Open Session Meeting of the Ayer Planning Board
Agenda

**Public Meeting, Stratton Hill Preliminary Subdivision Plan,
35 lots off of Wright Road**

Staff Report #1: Plan Acceptance, Open Public Meeting

STRATTON HILL PRELIMINARY SUBDIVISION PLAN

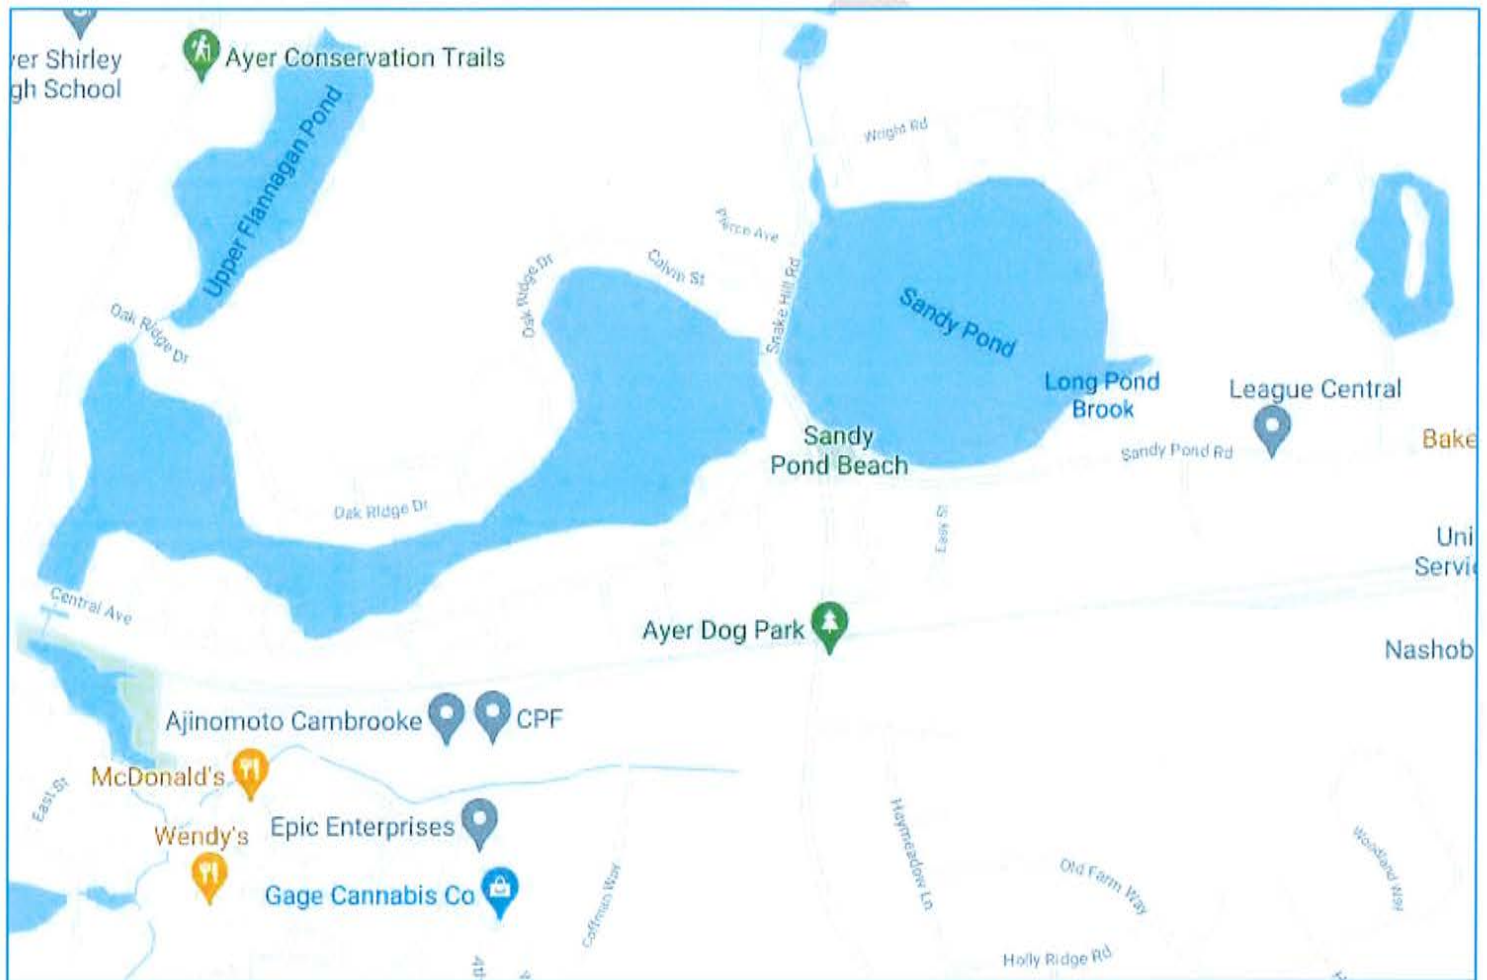
Note: I will mark the above map to better show Stratton Hill Road and call key intersections and approximate locations for ATRs. The subdivision will be in the upper right hand corner off Wright Road.
